Product Change Notice (PCN)

PCN Number: PCN-0450216R-01

Product(s) Affected: MD-SV series (part numbers MD-30SV, MD-40SV, MD-50SV, MD-60SV, MD-70SV, MD-80SV).

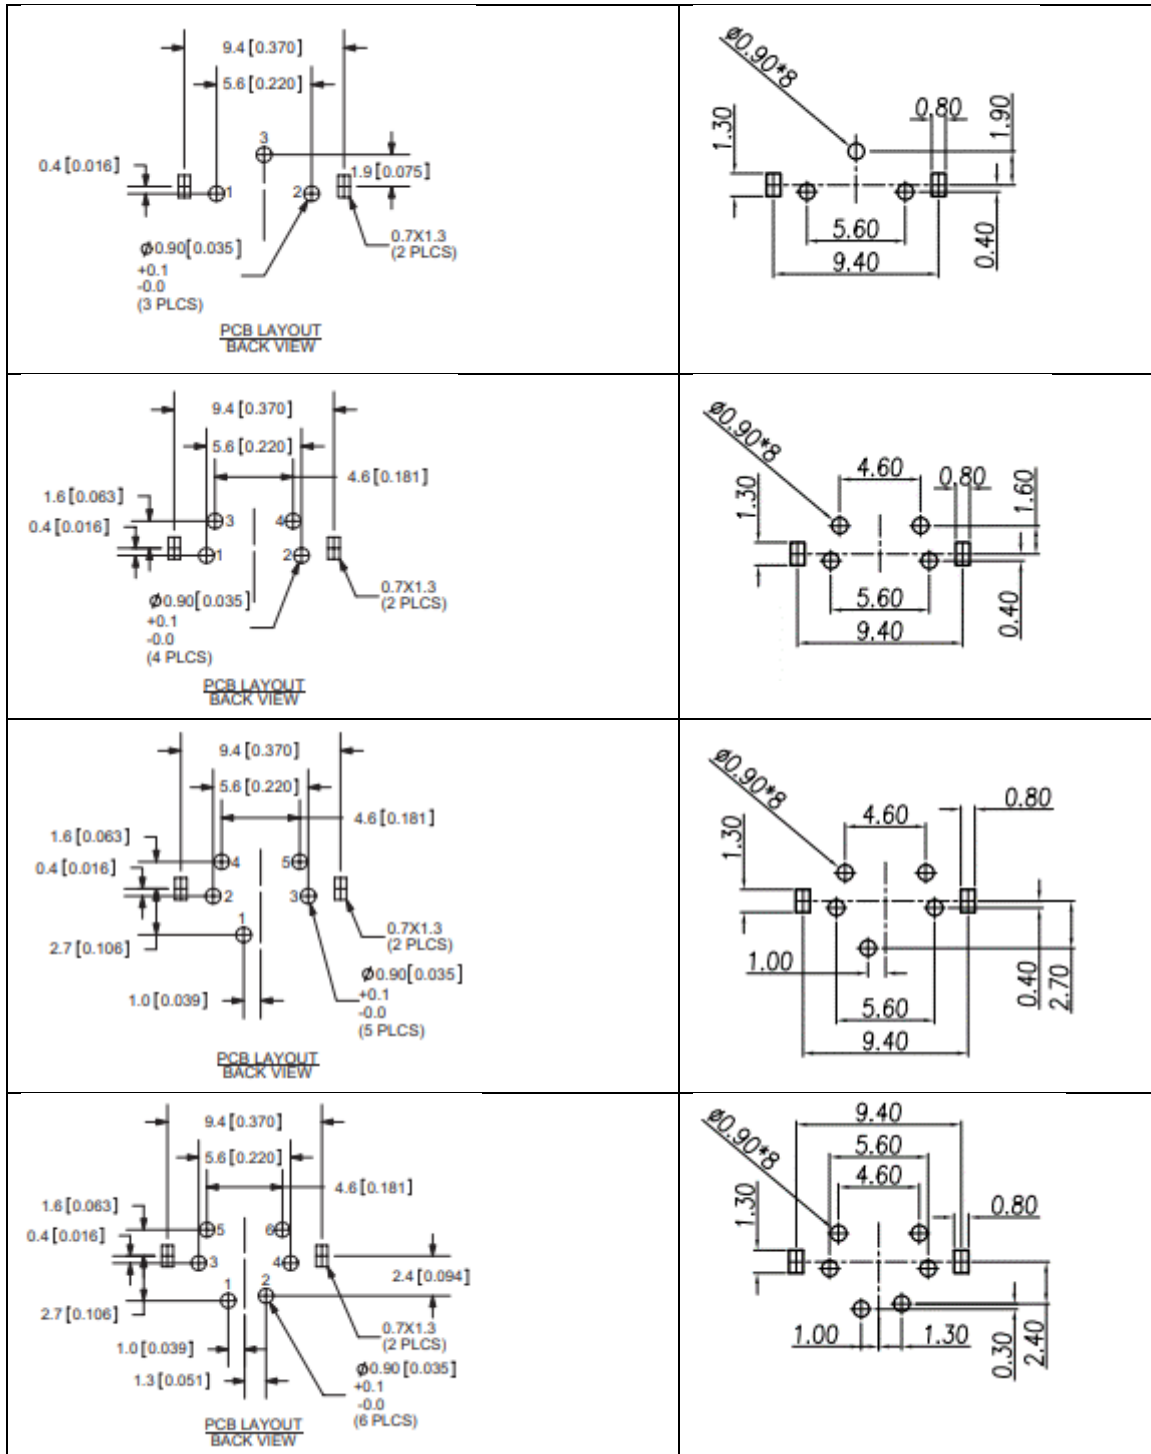
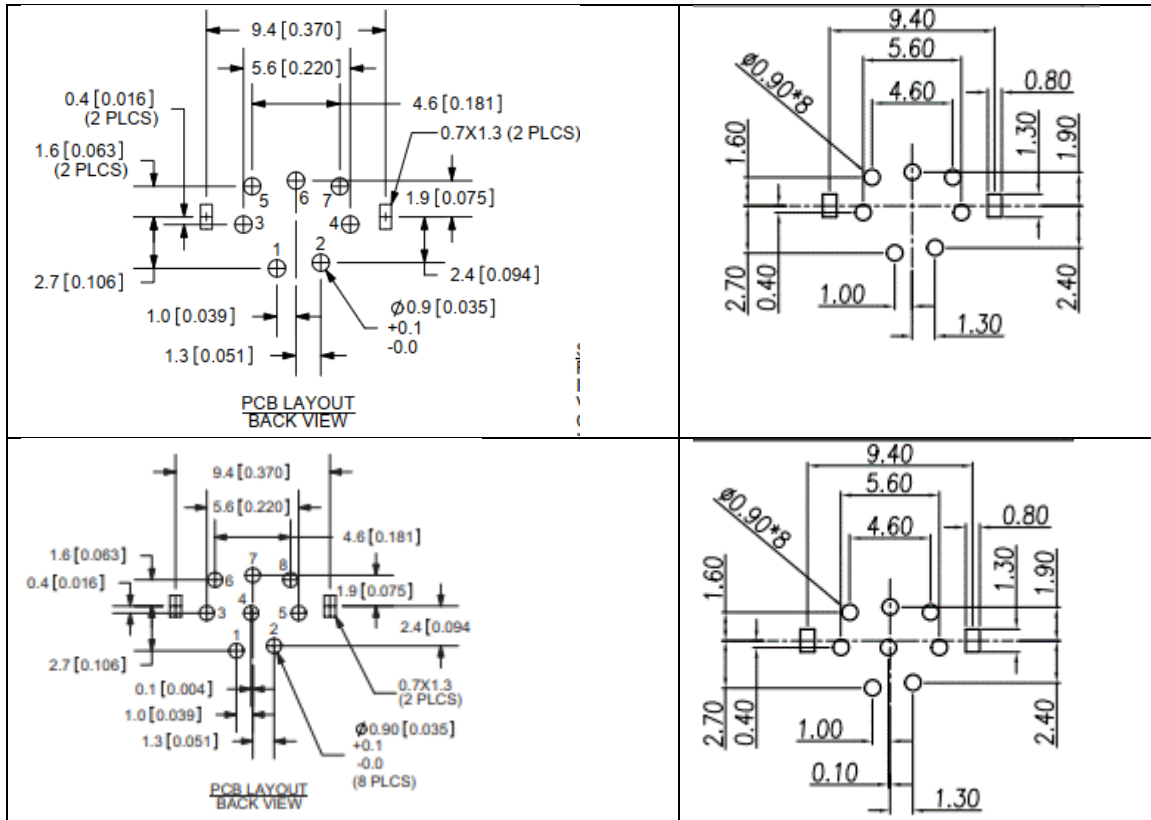
Description of Change: minor dimensional changes, such as pin length as shown below.
